Draft: January 12, 2022
Revised Draft: March 2, 2022
CT3058.00

**Re: Lake Simcoe Region Conservation Authority Comments – Hydrogeological Investigation, Water Balance, and Catchment-Based Water Balance
7370 Centre Road, Uxbridge, Ontario**

Terrapex Environmental Ltd. (Terrapex) is pleased to submit this letter summarizing additional information requested by the Lake Simcoe Region Conservation Authority (LSRCA) as part of comments received, dated August 18, 2021. The comments provided to Terrapex were directed toward the report completed by Beacon Environmental Ltd. (*Hydrogeological Investigation, Water Balance, and Catchment-Based Water Balance – 7370 Centre Road, Uxbridge, Ontario* released in February of 2021).

FIGURE 5

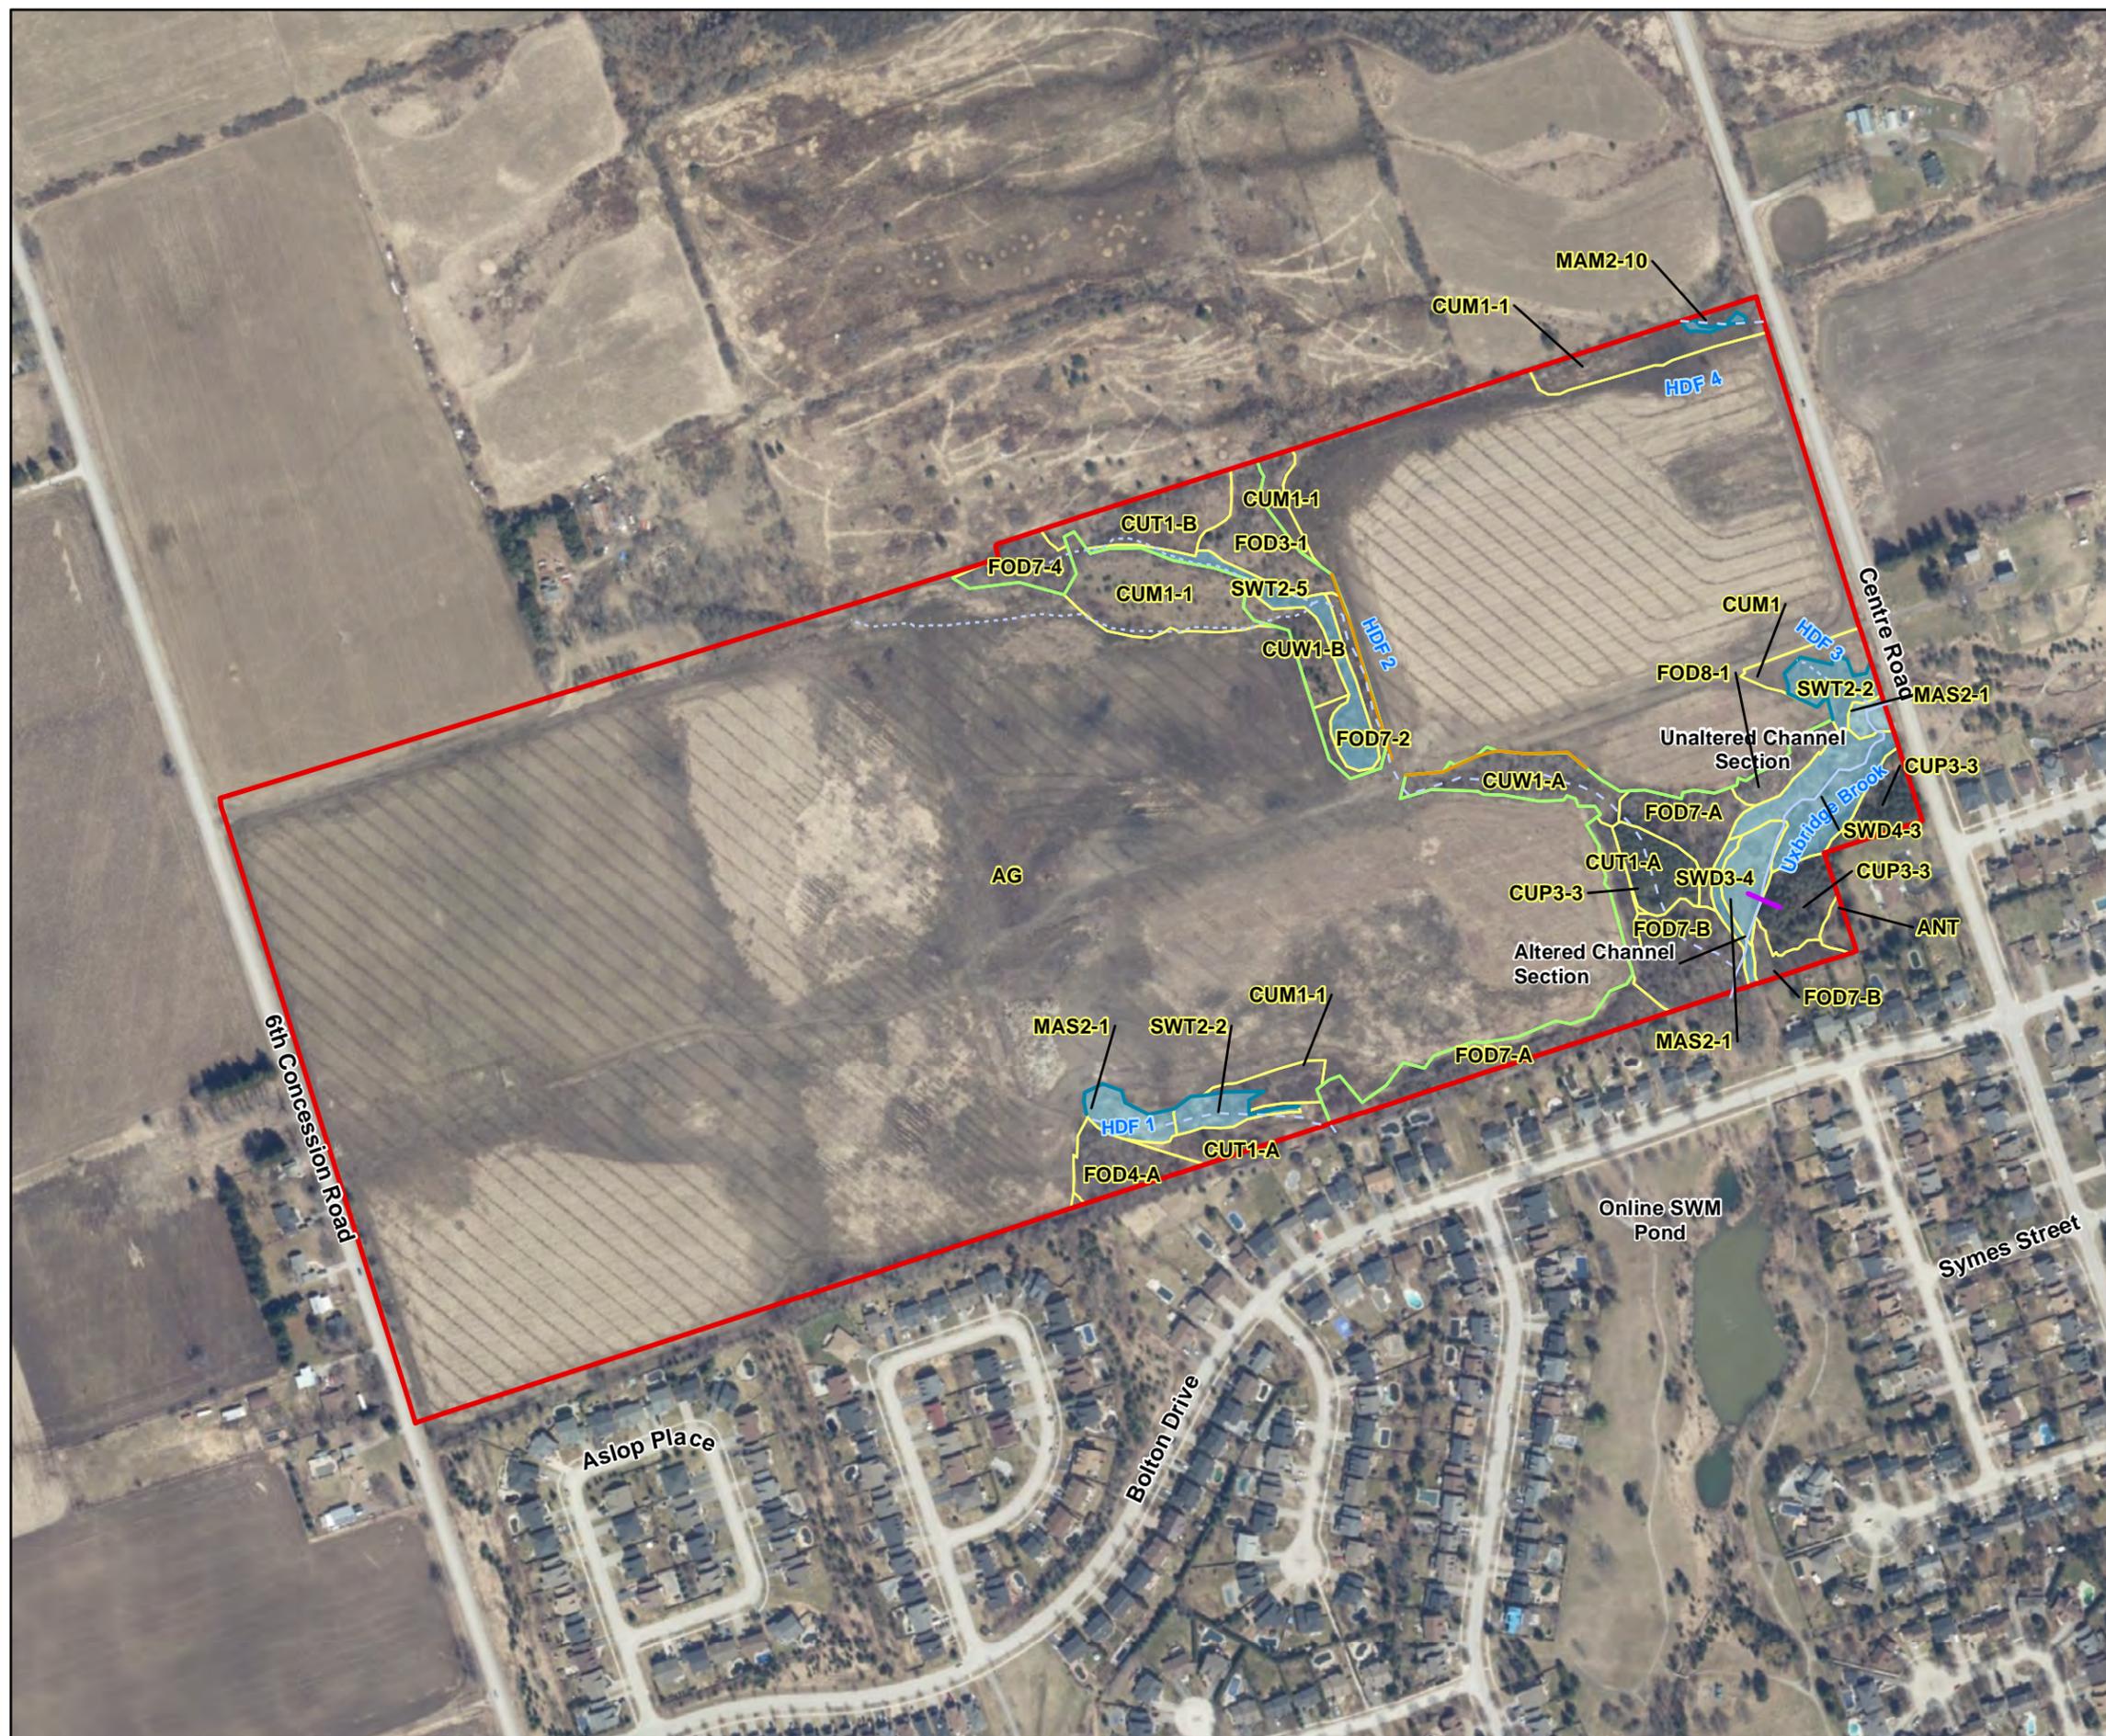
H8

It appears these areas maybe based on a figure in another report (Beacon, 2020) which is not include here, therefore it is unclear how each land use type corresponds to the subject site.

Please provide a pre- development figure clearly indicating all land use types used within the water balance assessments.

Response:

Please find the appended figure from Beacon, 2020.
